Pinehaven Stream - Flood Mapping Audit

Prepared for Greater Wellington Regional Council

Prepared by Beca Ltd (Beca)

13 July 2015

Figure 5.1 – Q100 (including culvert blockage, climate change and freeboard) flood extent at 27 Elmslie Road

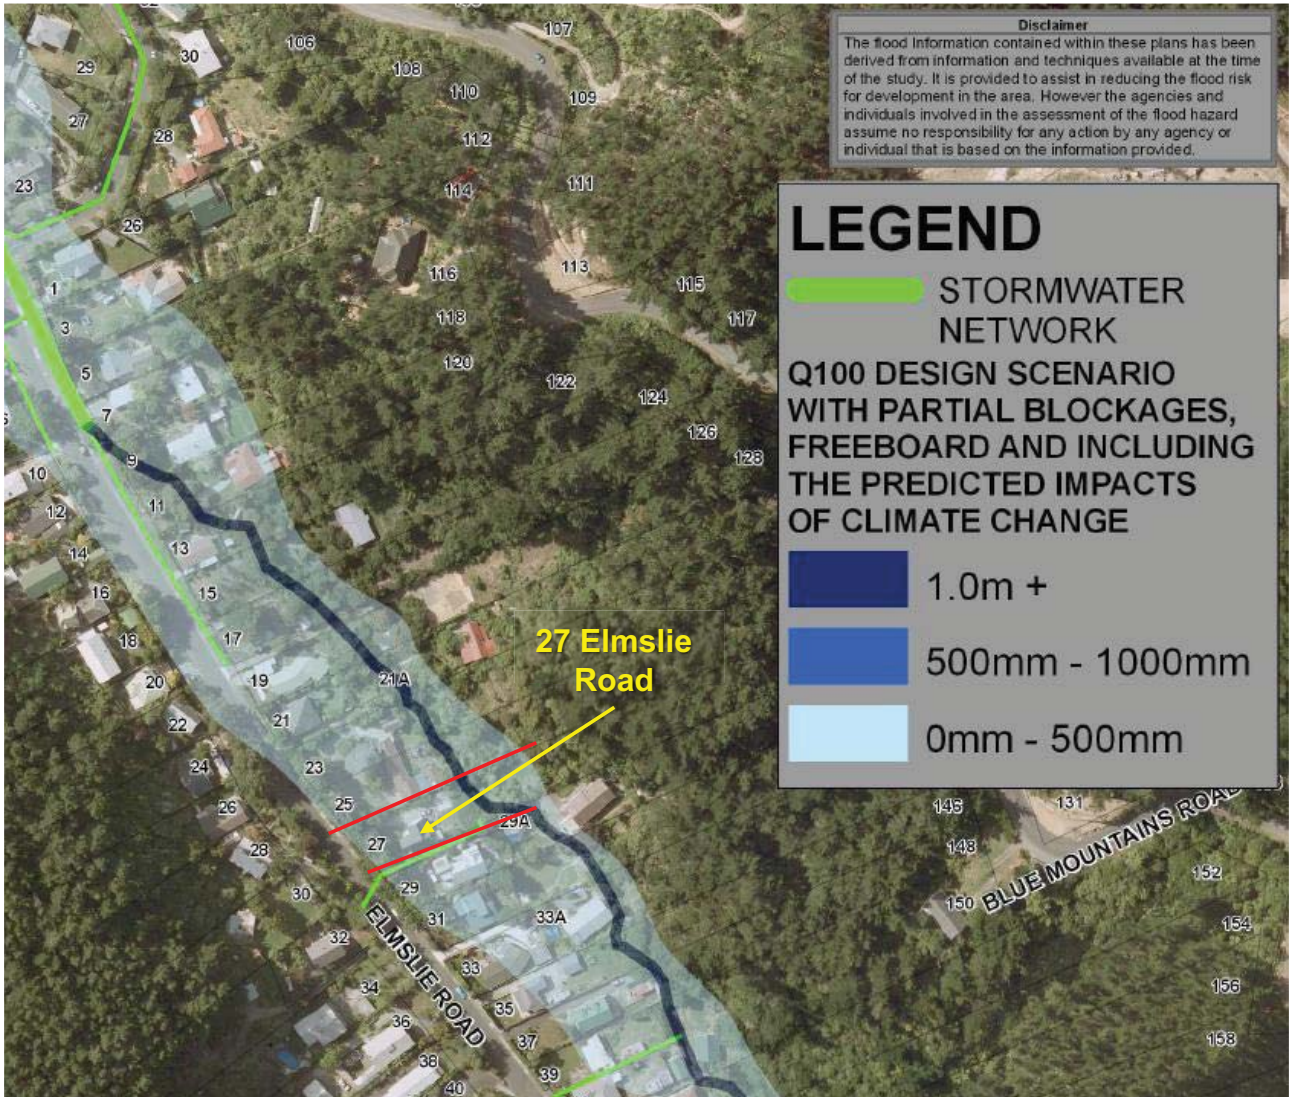
We note that the varying water level surface is confirmed by the Q100 flood map (Figure 5.1), which shows that flood depth across the site is less than 500 mm. If the water surface were flat across the cross-section, flood depth of more than 500 mm could be expected close to the stream channel due to the slope of the ground. With the water level surface dipping towards the stream, the active cross-section area will be lower than the 15 m² that was calculated by SOH, and hence the calculated flow will also be lower.

Figure 5.2 Flood extent elements

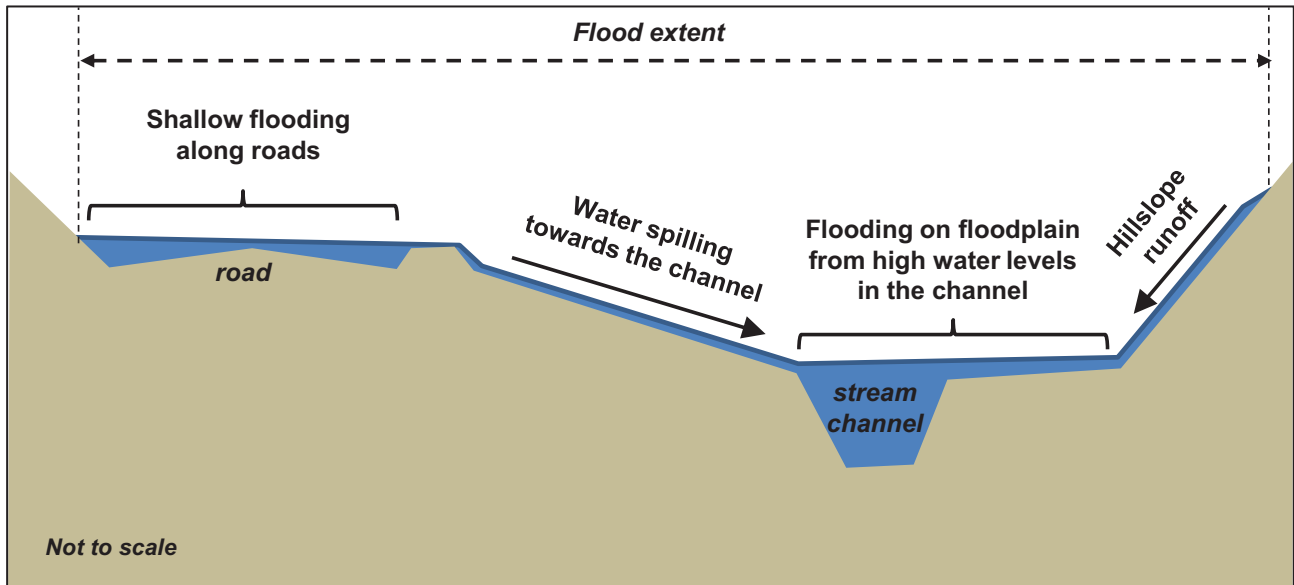
Figure 5.2 represents some of the elements that could contribute to the definition of the flood extent; illustrating why:

- The flood level may be different on opposite sides of a valley when 2D modelling is used.
- Why it may be inappropriate to assume that the water surface is flat across the flood extent.

As well as inundation of the floodplain adjacent to the stream channel, the flood extent may be extended laterally by hillslope runoff towards the channel, secondary overland flow paths (such as roads), and water spilling between secondary flow paths and the stream channel.

Figure 8.1 – Existing and maximum probable development hydrographs

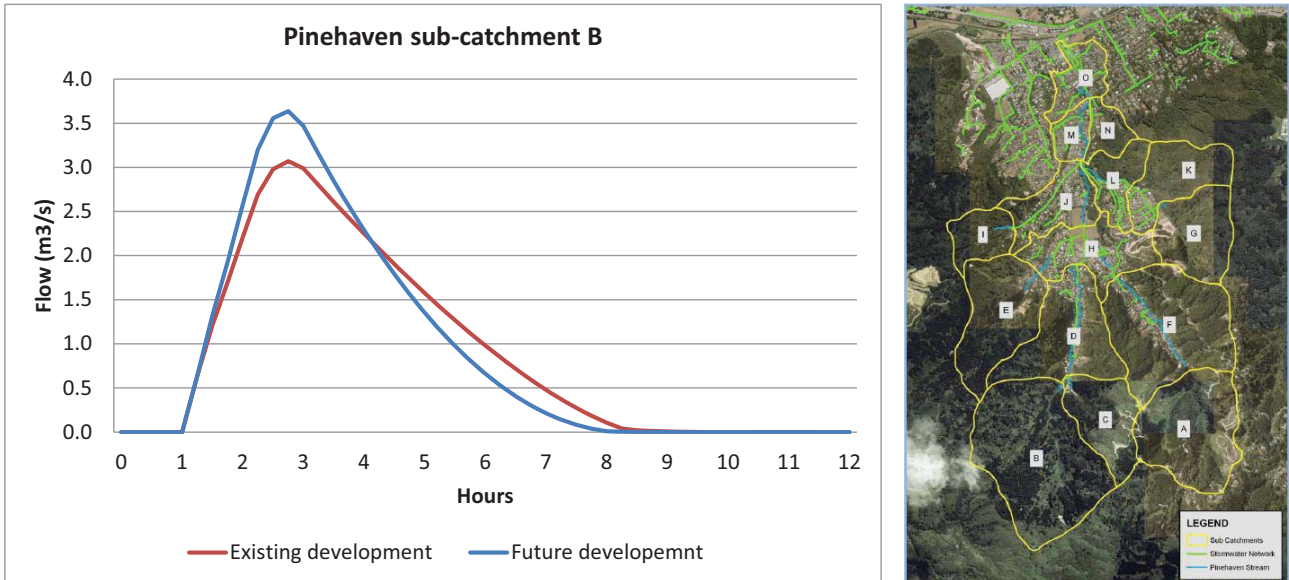
Figure 8.1 shows the change in flood hydrographs for existing development (*E4_Q100CC_2hr_HB.bnd11*) and future development (*E4_Q100CC_FP_2hr_HB.bnd11*) for sub-catchment B, which is in the southwest of the catchment and drains to the top of Pinehaven Road. Future development increases the peak flow by 18% (from 3.07 m³/s to 3.64 m³/s), and the flow recession is steeper than for the existing land use. However, the flood volume does not increase. This is unexpected, as increasing the impervious area of sub-catchment by 40% to reflect the development would be expected to reduce rainfall losses and increase runoff volume. Similar results were found for sub-catchment E, which drains to Wyndham Road.

Assuming a 100-year ARI plus climate change rainfall depth of 87.1 mm for the 3-hour storm, an Initial Loss of 5 mm, Ongoing Loss of 2 mm/hr, and 40% impermeable area for the affected post-development sub-catchments, then the effective rainfall depths would be;

- 76.7 mm (88%) for existing land use
- 80.8 mm (93%) for post-development land use

The difference between existing and post-development flood volumes would be expected to be to a similar ratio. The existing ground cover of bush and pine forest on sloping catchments generated relatively high runoff, when compared to natural vegetation on flatter ground. This is reflected in the 88% effective rainfall for the existing situation and only 5.6% increase in effective rainfall post-development.

Figure B.1 – SOH slide 1 for 27 Elmslie Road

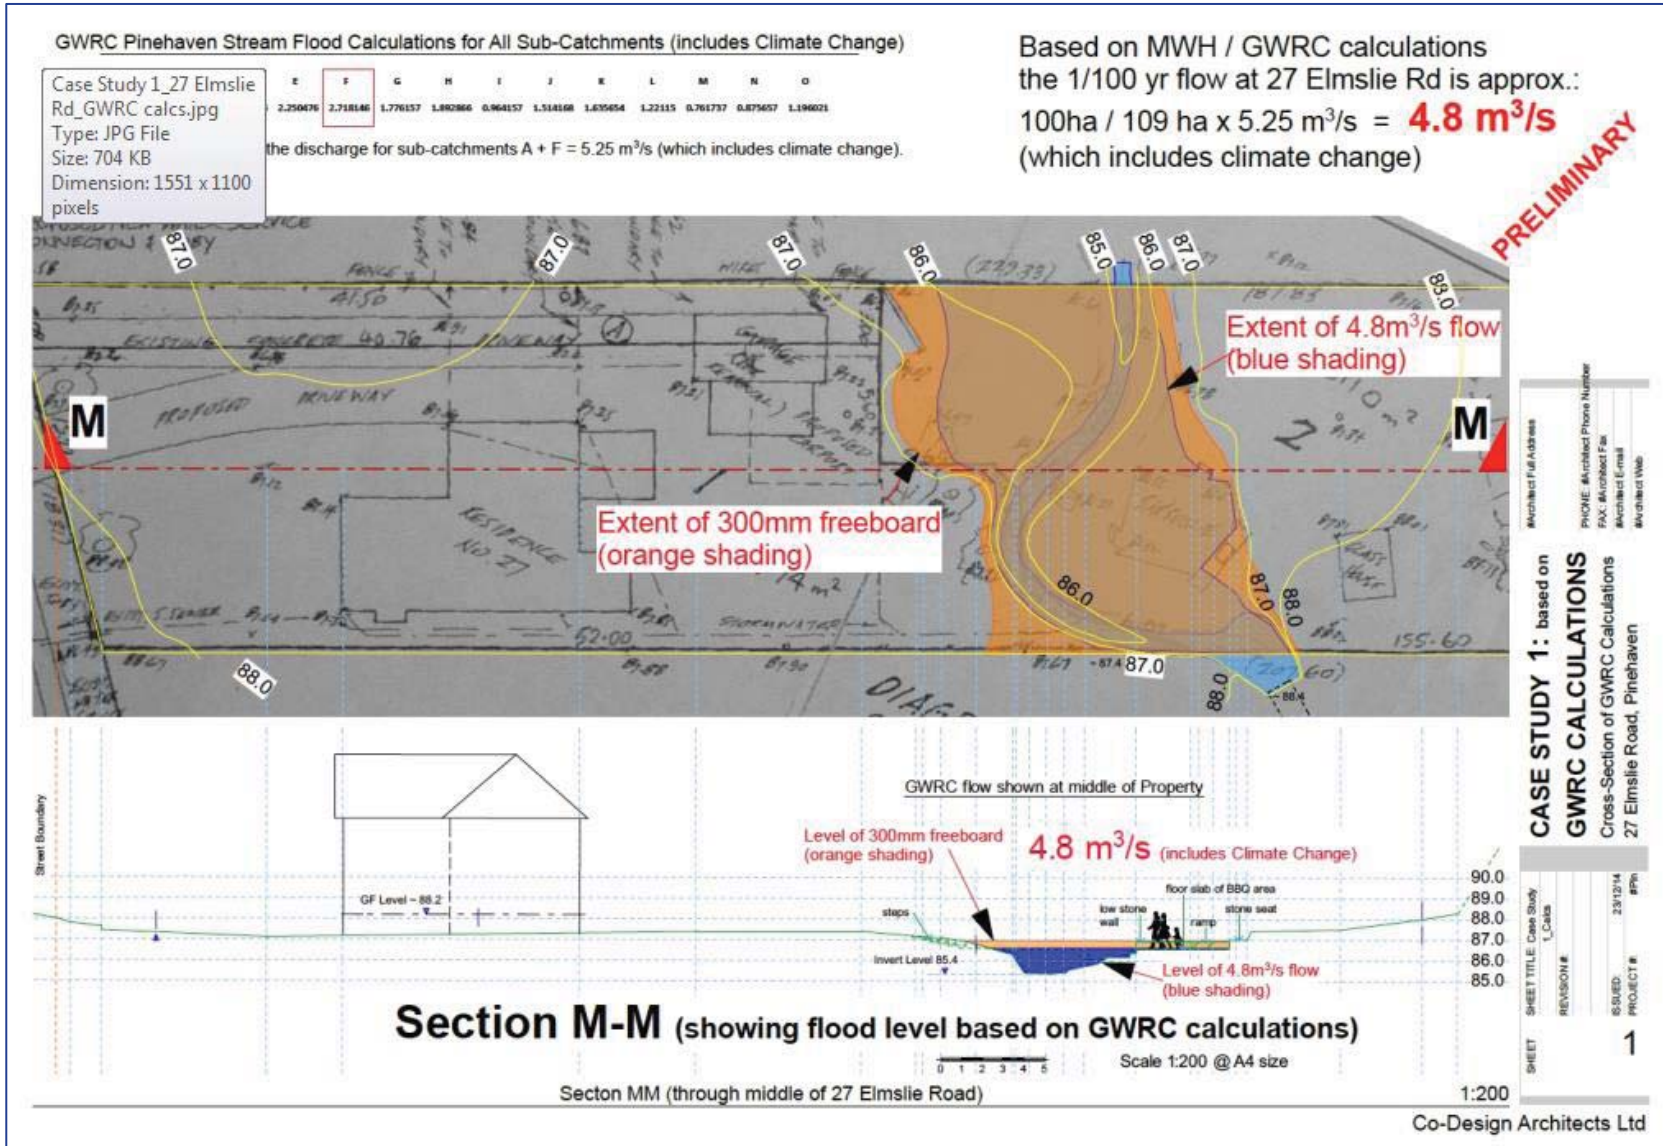
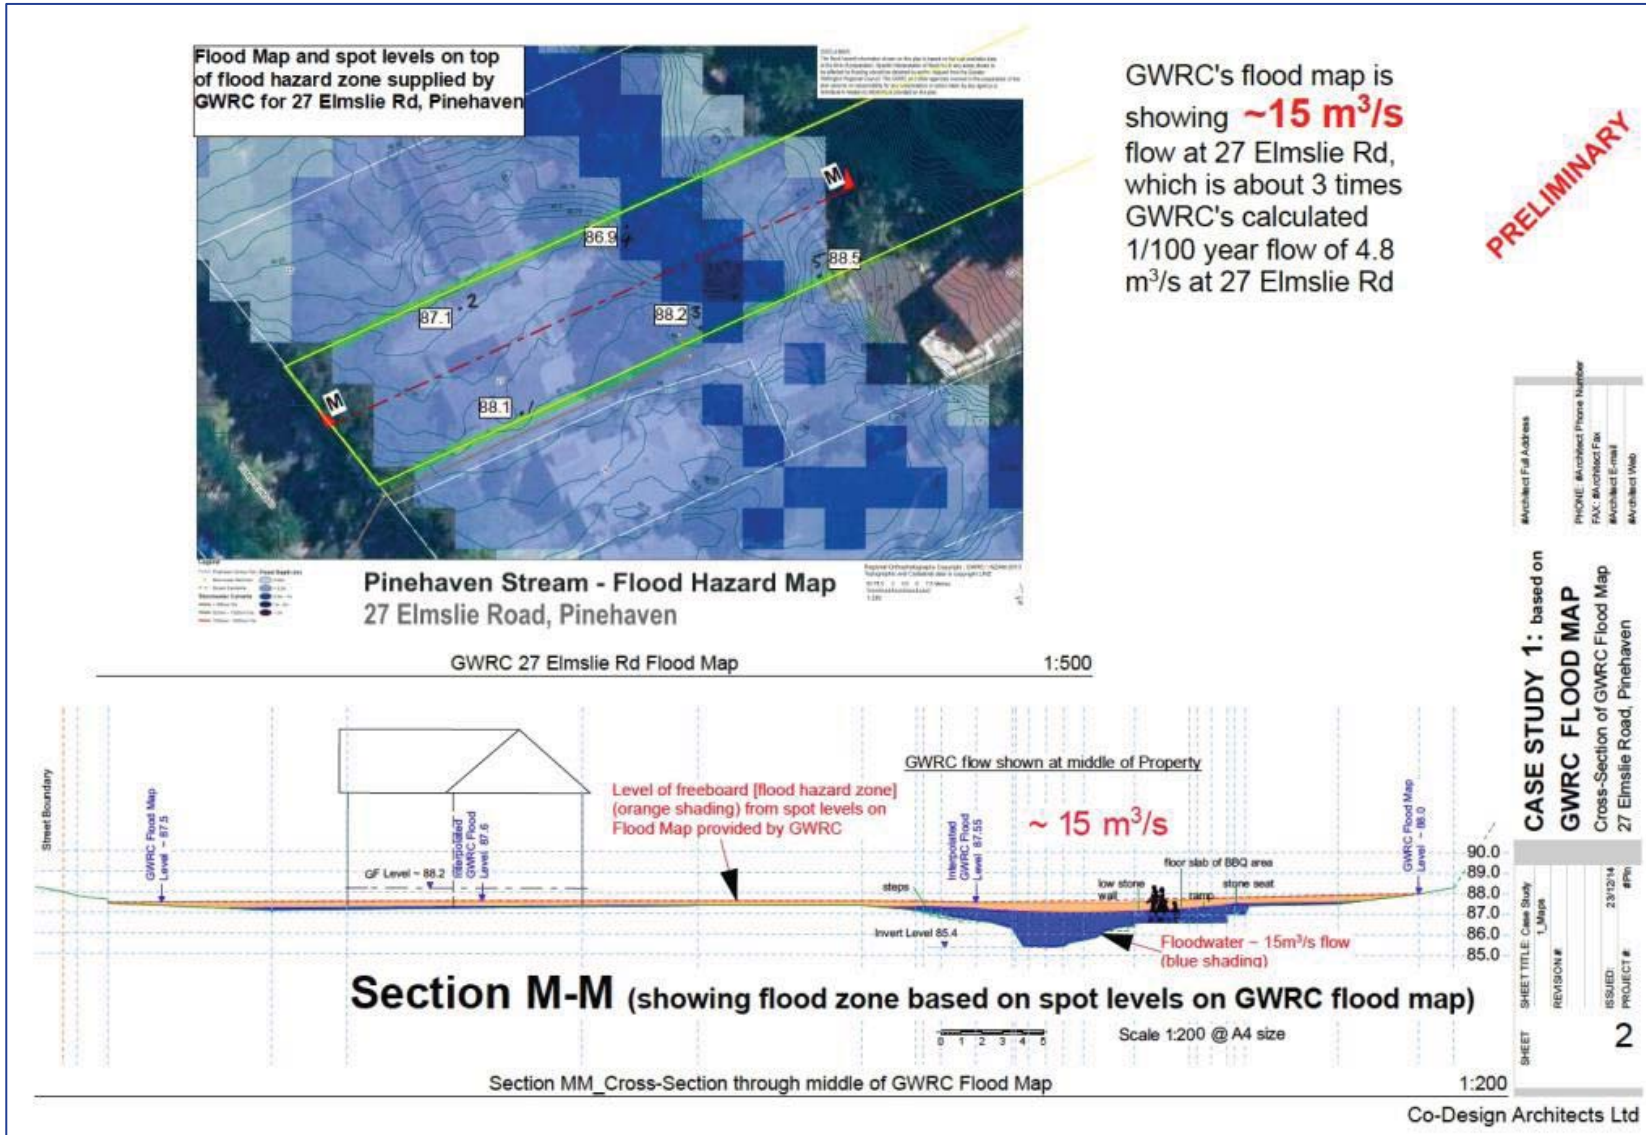
Figures B.1 and B.2 in Appendix B show the information provided by SOH for 27 Elmslie Road. At this location, the Flood Hazard Map extent is approximately 70 m wide, stretching from edge of Elmslie Road to approximately 15 m beyond the stream channel on the true right (east) bank.

Elmslie Road runs along a relatively narrow valley containing a tributary of Pinehaven Stream. At No. 27, the edge of the road is approximately 50 m from the stream, with the property between the road and the stream. The ground cross-sections produced by SOH and contained within the 5 m gridded model bathymetry show that ground level around the house to be about 1.0 m to 1.5 m below road level, while SOH's cross-section indicate that the bed of the stream is a further 2 m lower.

One critical area of difference between SOH's understanding of flood/hazard extents relates to the water surface across the cross-section. As noted above, SOH assumed that the water surface is flat, while SKM have provided cross-sections that indicate that the water level varies across the cross-section. Figure B.3 in Appendix B shows modelled water levels for SKM's sections in the vicinity of 27 Elmslie Road. The water levels were extracted from the 2D surface model results. They indicate shallow flooding (as low as 10 mm) at the margins of the floodplain, and lower water levels in the main channel. This may be due to overland flow paths on the floodplain carrying flow that has broken out from the stream channel upstream.
